SUBJECT: Additional Information - TMI Unit 1 25th Year Reactor Building
Tendon Surveillance Report

Three Mile Island, Unit 1 (TMI Unit 1)
Operating License No. DPR-50
NRC Docket No. 50-289

Enclosure: 1) Three Mile Island Unit No. 1, 25th Year Reactor Building Tendon Surveillance
(Period 7), Topical Report No. 136, Revision 1, July 31, 2001

AmerGen		DOCUMENT NO.	
		TR 136	
TITLE 25 th Year Reactor Building Tendon Surveillance (Period 7)			
REV	SUMMARY OF CHANGE	APPROVAL	DATE
00	Initial Issuance		
01	<p>TMI-1's past practice of applying the normalizing force to Figures 1, 2, and 3 of Section 5.4, "Tendon Force Trends" has been questioned by the reviewer. The reviewer has indicated that TMI is an outlier in the industry, as TMI-1 applies the normalizing force to its individual as-found tendon lift-off forces when plotting the vertical, hoop, and dome tendon forces vs. log of time trend plots. As such, TMI-1 has concurred with the reviewer's request to remove the normalizing force for plotting the force vs. time trend plots, and resubmit the report and all affected portions therein for AMERGEN resubmittal to NRC. Also, TMI-1 has revised Figures 4, 5 & 6 (Control Tendon Trends) to sh

Figure 1
Vertical Tendon Force Trend

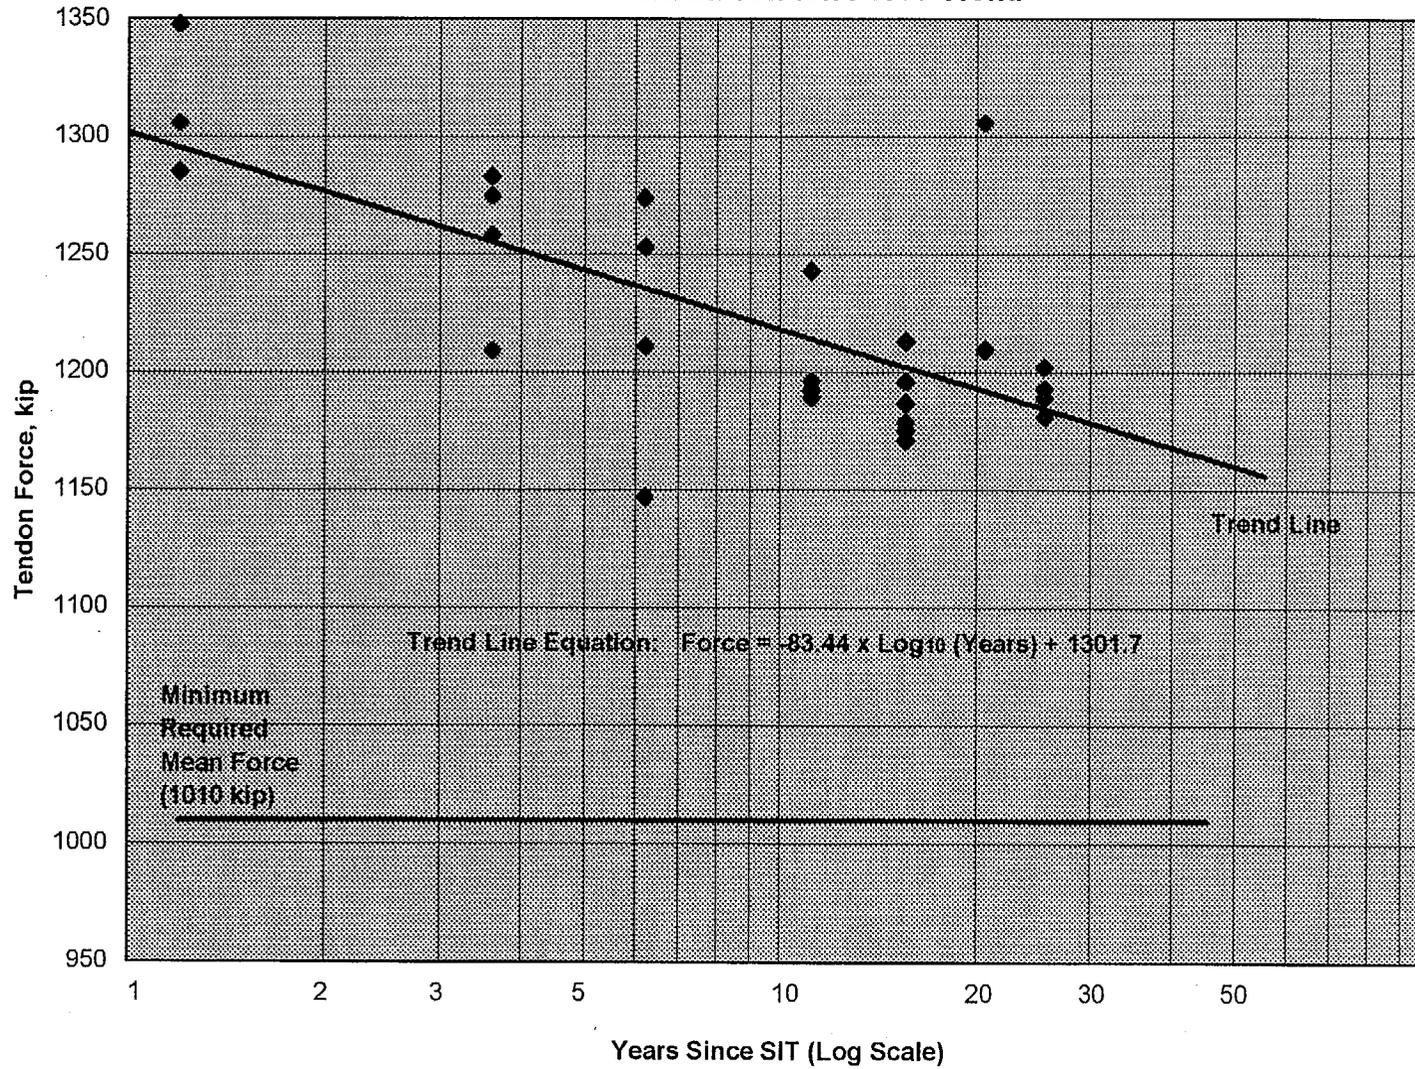
In a conference call on March 7, 2001, the NRC questioned the approach of applying normalizing forces to the individual as found tendon lift-off forces when plotting the vertical, hoop, and dome tendon forces vs. time trend plots in Attachment 1 to the TR. In response to the NRC's request enclosed is TR No. 136, Revision 1, in which the normalizing forces have been removed. The conclusions of the report are unchanged.

Figures 1 & 3 show that all vertical and dome tendon forces measured to date are well above the minimum required mean forces specified in FSAR Par. 5.7.5.2.3.f (Update 15). In addition, the trend lines remain well above the applicable minima for many decades after the current TMI-1 operating license expires. It can, therefore, be concluded that the mean levels of force in the vertical and dome tendon groups will not fall below the respective minima prior to the next surveillance or, in fact, prior to any surveillance performed during the period of validity of the current operating license.
